# Access Compliance Report

## Public Rights-of-Way

### (Curb Ramps)

Intersection ID: 30548	Main Street: SOUTH_BV	Cross Street: N/A	Location: SE
ADA ID: 644549393726	Ramp Type: Perp	Initial Pass/Fail: Pass	Overall Compliance: No
Codes/Mitigation Info/Possible Solution		Field Measurements/Component Compliance	
Severity Score: 12.75

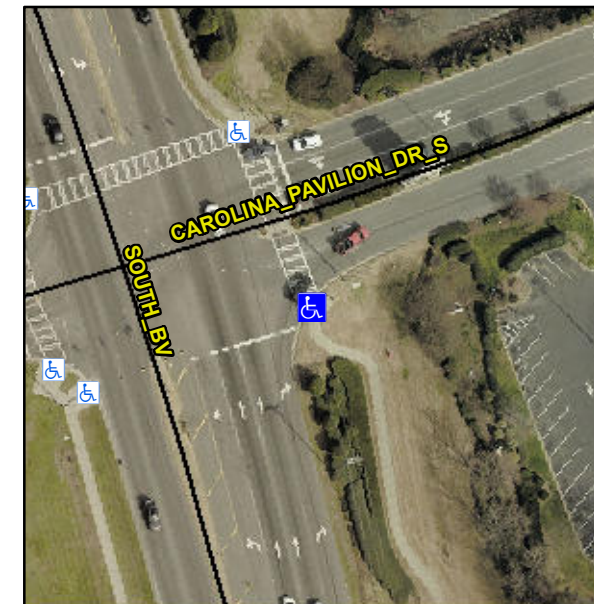
**R304.2.1, R304.2.2-Perp, R304.3.2-Para, R304.5.3, R305.1.4, R305.2**

Compliance	Description	Data	Compliance	Description	Data
N/A	Ramp Length (in)	94.0	Yes	Ramp Slope (%)	6.2
Yes	Ramp Width (in)	60.0	Yes	Ramp XSlope (%)	2.9
N/A	Flare Type LT	Sloped	N/A	Flare Type RT	N/A
N/A	Flare Slope LT (%)	5.2	Yes	Flare Slope RT (%)	5.0
N/A	Flare Traversable LT?	Yes	N/A	Flare Traversable RT?	Yes
No	Landing Length (in)	N/A	Yes	DWS Provided?	Yes
No	Landing Width (in)	N/A	Yes	DWS Contrast?	Yes
No	Landing Slope (%)	N/A	Yes	DWS Length (in)	24.0
No	Landing X Slope (%)	N/A	No	DWS Full Width?	No
N/A	Landing Curb? (Y/N)	No	No	DWS Offset (in)	5.0
N/A	Shared Landing?	No			
Yes	Gutter Ponding?	No	Yes	Gutter Slope (%)	0.2
Yes	Gutter Lip Ht (in)	0.0	Yes	Gutter X Slope (%)	0.7
N/A	Painted X Walk1?	Yes	N/A	Painted X Walk2?	N/A
	X Walk 1 Direction	To N		X Walk 2 Direction	N/A
N/A	X Walk 1 Width (in)	134.0	N/A	X Walk 2 Width (in)	N/A
	X Walk 1 Slope (%)	2.3		X Walk 2 Slope (%)	N/A
	X Walk 1 X Slope (%)	3.0		X Walk 2 X Slope (%)	N/A

Yes	Ramp inside XWalk1?	Yes	N/A	Ramp inside XWalk2?	N/A
	Road Slope (%)	N/A	N/A	Clear Space?	Yes
	Road X Slope (%)	N/A	N/A	Clear Space to XWalk (in)	N/A
Yes	Any Obstructions?	No	Yes	Storm Grate/Utility Hazard?	No
	Obstruction Type			Storm Grate/Utility Type	
		N/A			N/A
			Yes	Surface Condition? (G/P)	Good

**Remove & Replace Entire Ramp.**
